DELAWARE RIVER BASIN  
TRIBUTARY TO MAIDEN CREEK  
BERKS COUNTY  
PENNSYLVANIA  
NDS ID PA. 00721  
DER ID 6-460

# CHRISTMAN DAM

## PHASE I INSPECTION REPORT NATIONAL DAM INSPECTION PROGRAM

PHASE I INSPECTION REPORT  
NATIONAL DAM INSPECTION PROGRAM  
CHRISTMAN DAM  
NATIONAL ID NO. PA 00721  
DER NO. 6-460

FIELD OBSERVATION PLAN  
CHRISTMAN DAM

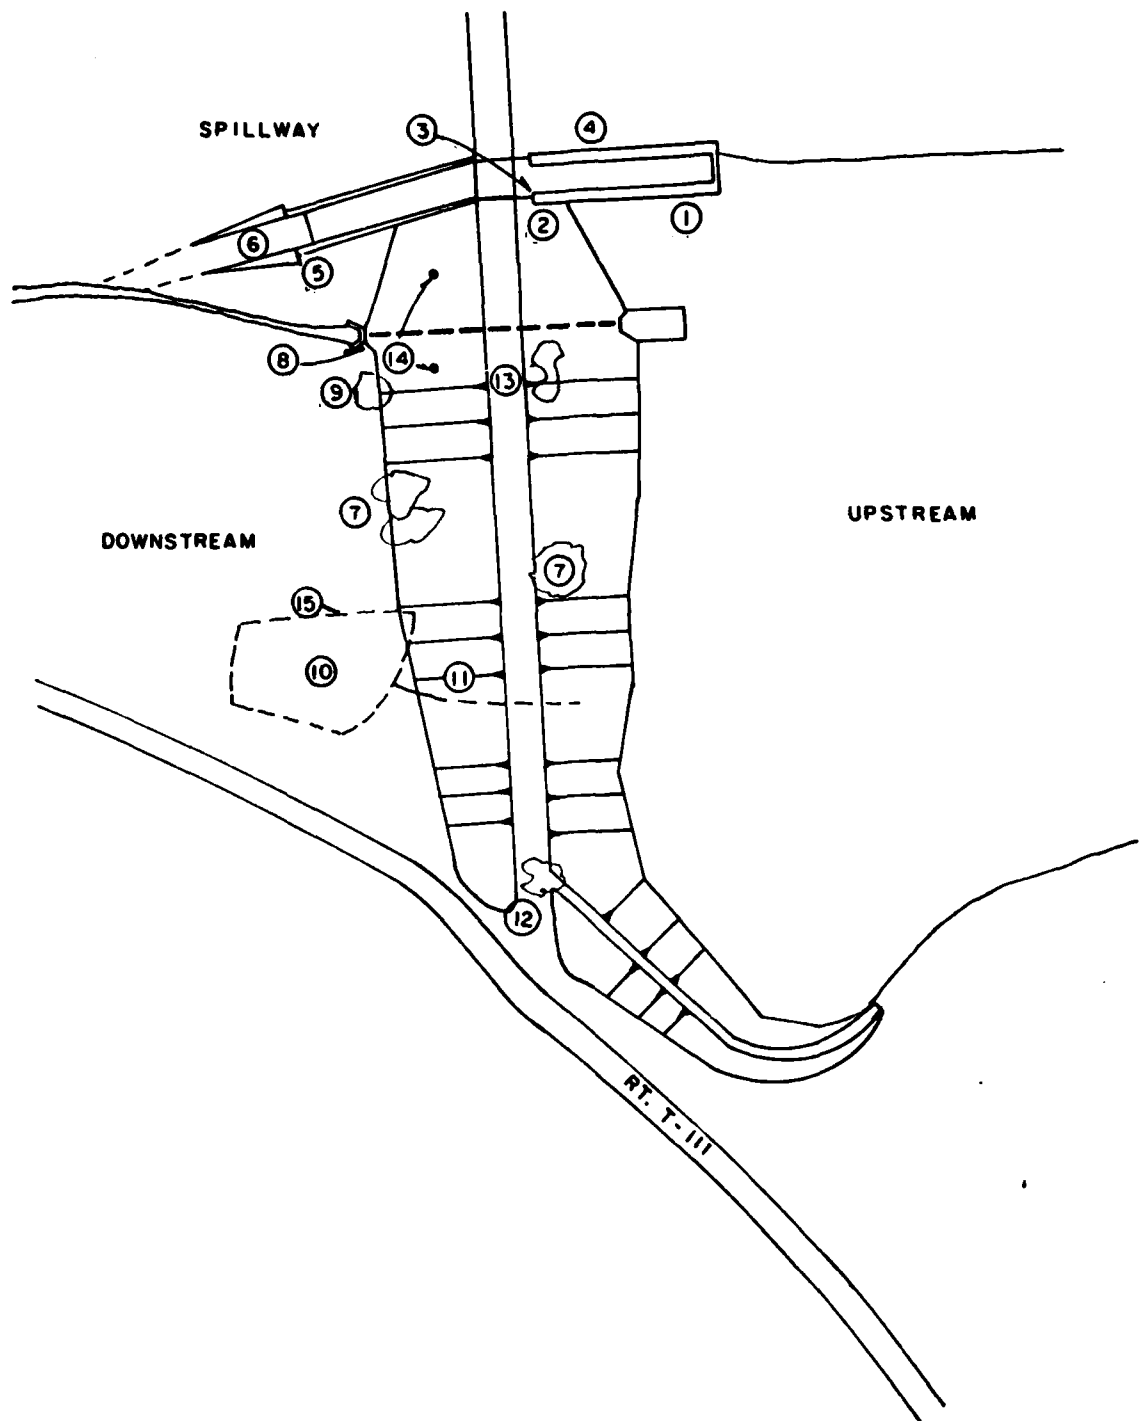
Between the spillway chute and the discharge conduit outlet, slightly downstream of the toe, a marshy area was noted, as shown on sheet 5a, Appendix A. Seepage was also noted exiting the embankment from the left side of the outlet conduit, as shown in Photograph 13. This seepage could either be embankment seepage intercepted by the rock toe or seepage along the conduit.

*See Sheet 5a. Seepage was noted from under a fish pond located immediately downstream of the dam. It could not be determined if the seepage was from the fish pond or from the main reservoir.*

*Four piezometers have been installed at two locations as shown on Sheet 5a.*

## GENERAL WALL REPAIRS

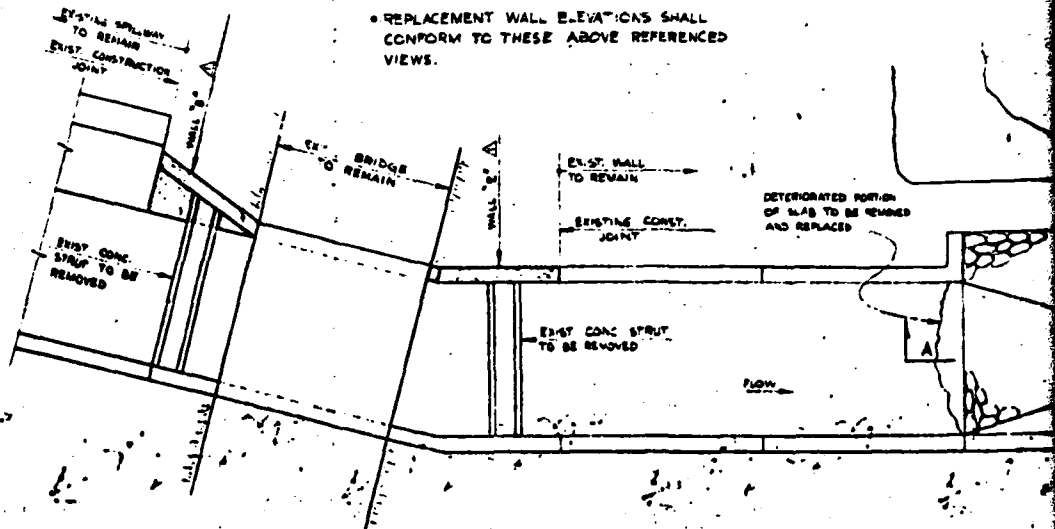
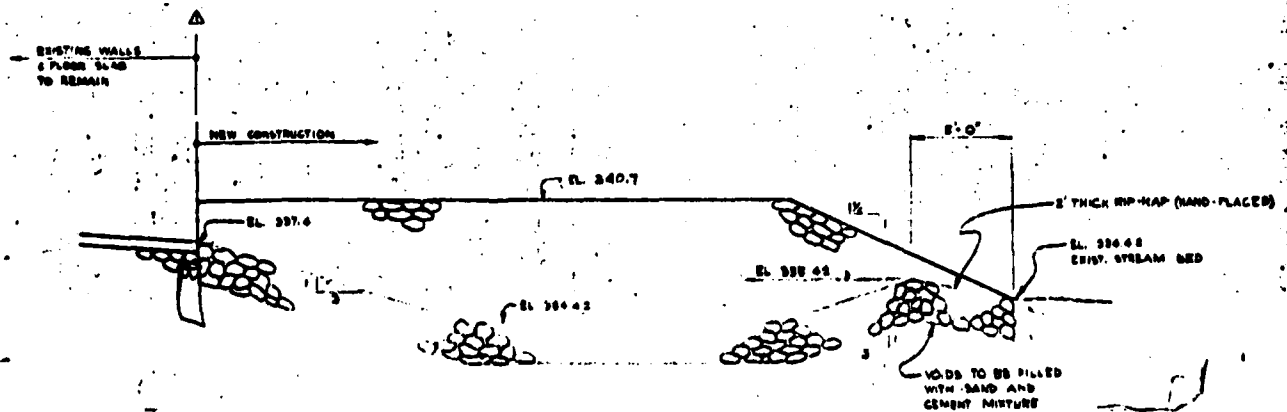
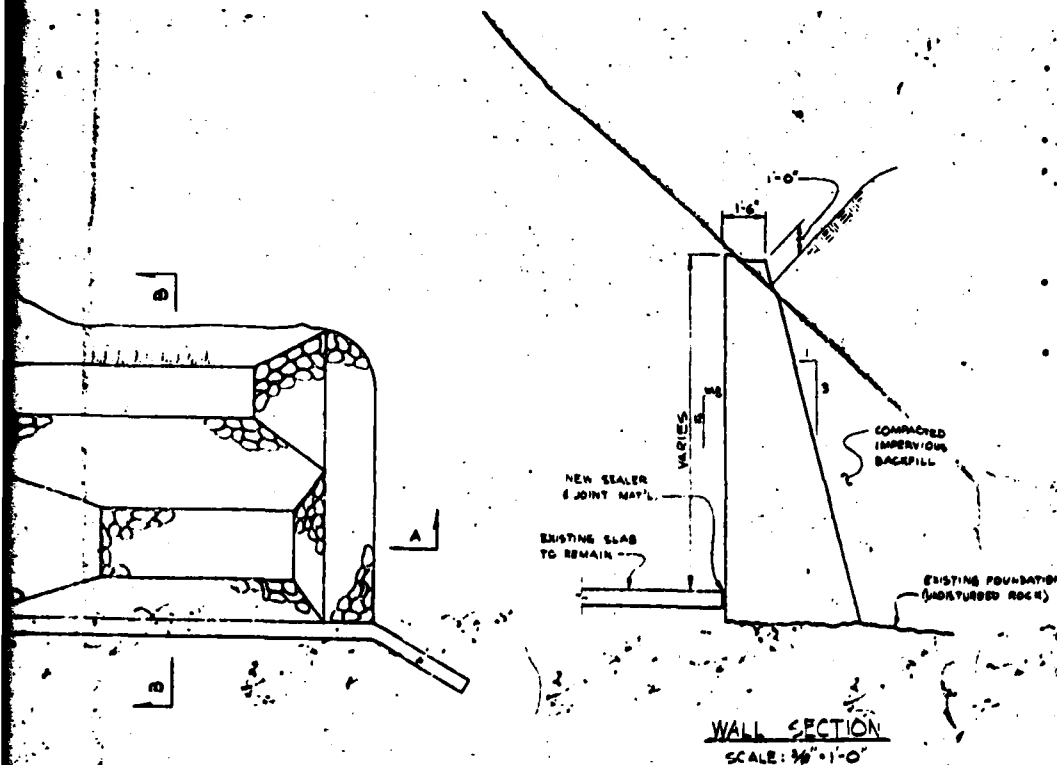
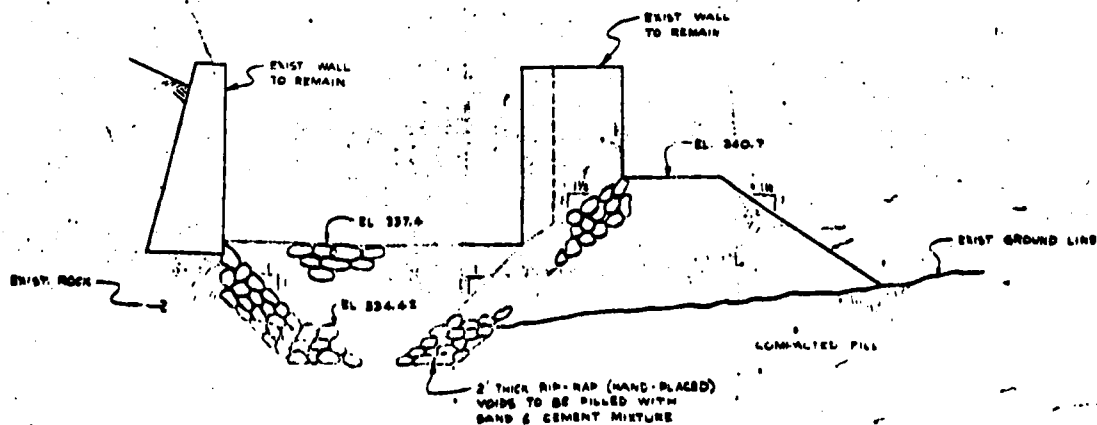
- ① Cut off wall with accept holes under and of plate
- ② Upper wire screen behind accept holes
- ③ This sheet is new. If there are any changes on other sheets they should be marked.
- ④ It would be better to have fill go to top of walls & properly sealed so surface run off would not be trapped behind the walls.
- ⑤ No detail of vert. joint
